R645-301-522, Coal Recovery; Confirmation from the USDOJ / BLM / SLO that the resource recovery and protection plan(s) is adequate for each of the Federal coal leases which is being proposed for addition to the Bear Canyon Mine permit area. [PHH]

Re: Resource Recovery and Protection Plan (R2P2) Modification, Federal Coal Leases U-61048, U-61049, and U-46484, Co-Op Mining Company, Bear Canyon Mine, C/015/025

Appendix 5-C

Figure 5C-2

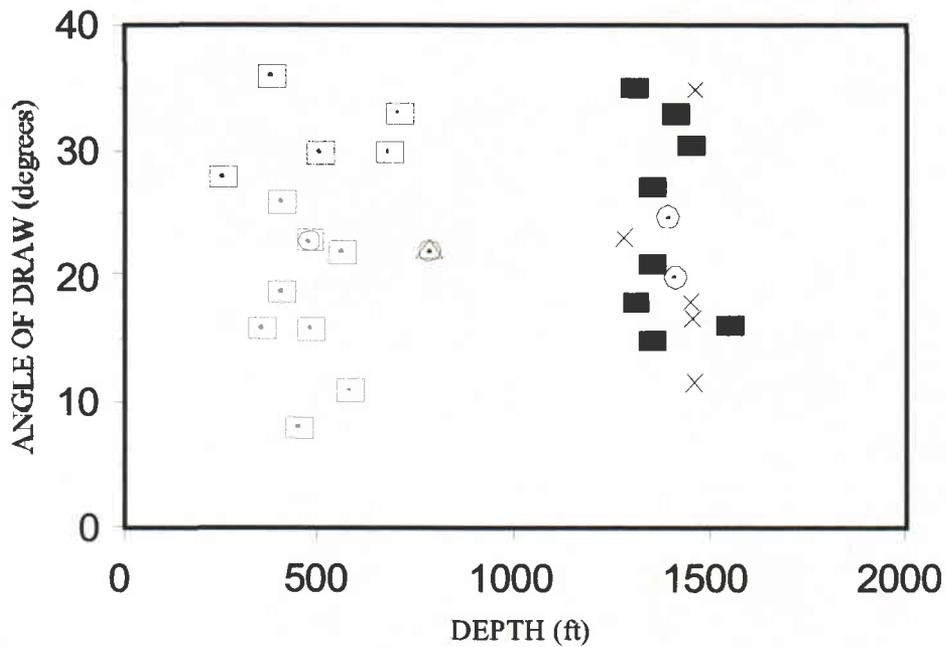
This Protection Zone was determined by examining the angles of draw. [Figure 5C-2](#) shows angle of draws plotted against depths for various mines within the general area of the Bear Canyon Mine. Based on this information, an average angle of draw of 22.5° was used.

To prevent subsidence to these escarpments in areas where it has been determined escarpment failure would be a hazardous condition, a barrier zone will be left in which no retreat mining will take place. The width of this barrier was determined using an angle of draw of 22.5° (See Figure 5C-2 and attachment 2).
